**Subject:** Proposed New Acceptance Criteria for Factory Applied Fire-Retardant Penetrant for Wood Structural Panels and Sawn Lumber, Subject AC516-1020-R3

Re: ICC-ES Proposal AC516-1020-R3  
"Factory Applied Fire-Retardant Penetrant for Wood Structural Panels and Sawn Lumber"

RE: Proposed New Acceptance Criteria for Factory Applied Fire-Retardant Penetrant for Wood Structural Panels and Sawn Lumber, Subject AC516-1020-R3

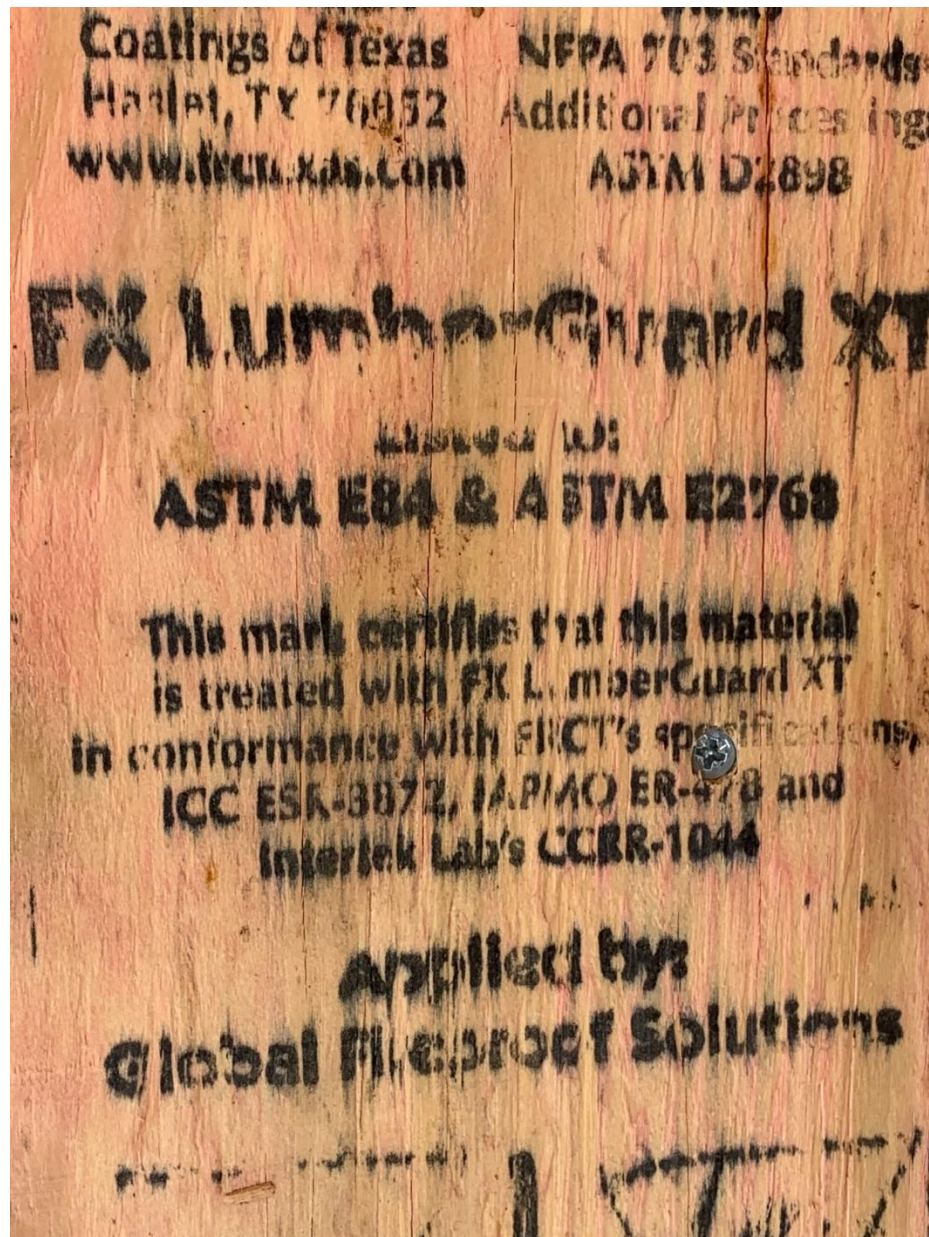
The above picture is a fire station built in Canton, GA 2020. During my regular commute I pass this site twice a day. Shortly after it was steel framed, several units of plywood in Global Fire Solutions paper wraps arrived on the job site and the plywood was being applied as wall and roof sheathing.

I stopped by this job site on Waleska Road / Rienhardt Parkway wondering what the orange wood was? The stamp list ESR-3872.

3872 is for division 9 architecture coatings. Not division 6 rough carpentry where Fire Retardant Treated Wood is defined in the codes. It also REQUIRES field testing.

This is out of spec, does not meet the codes, and been exposed to the elements uncovered for several weeks.

This product is not a substituted to Fire Retardant Treated Wood and does not have an approved ICC ESR Report for this end use.
